Proposed remedy for Comment #109
Tom Lindsay

Specifications (for Table 68-3)

Test figure (for subclause 68.6.4)

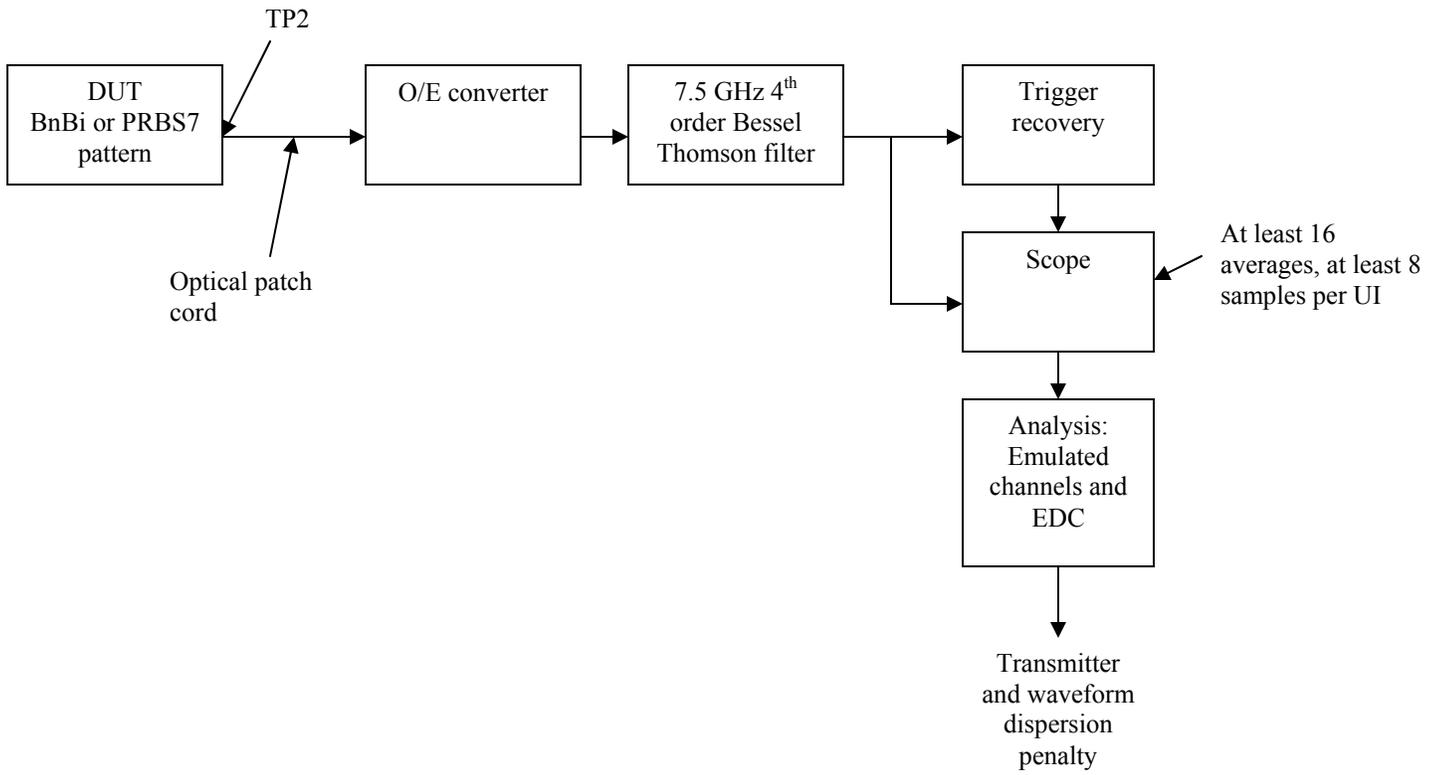
The transmitter waveform and dispersion penalty is intended to control deterministic dispersion. A waveform from TP2 of the DUT is to be captured on an oscilloscope for analysis to determine if its performance, when operating in conjunction with channels expected in the application, is within acceptable penalty bounds.

The DUT shall repetitively transmit the BnBi data pattern, as defined in clause 52.9.1.1, or a PRBS7 data pattern through a test patchcord into an O/E converter and through a 4th-order 7.5 GHz Bessel-Thomson filter. The filtered output data should then run into the oscilloscope and also into a trigger recovery circuit. The trigger recovery circuit must recover a suitable pattern and/or clock trigger for the scope so that the waveform can be captured and stored. Averaging of at least 16 waveforms, or equivalent, is required. An effective sample rate of at least 8 samples per unit interval is required. If the BnBi pattern is transmitted, then the specific sub-pattern is to be recorded. If PRBS7 is used, then the entire pattern is to be recorded. The DUT must be fully operational in both transmit and receive directions during this test.

The stored waveform is to be analyzed in combination with each of the three emulated channels equivalent to the ISI generators defined in subclause 68.6.5.1 for the TP3 static stressed sensitivity test and with an emulated reference EDC circuit. The reference EDC circuit is defined as equivalent to an infinite length decision feedback equalizer. The stored waveform may be analyzed with the emulated channels and EDC using the algorithm described by the following MATLAB code which calculates the worst penalty from the set of three emulated channels:
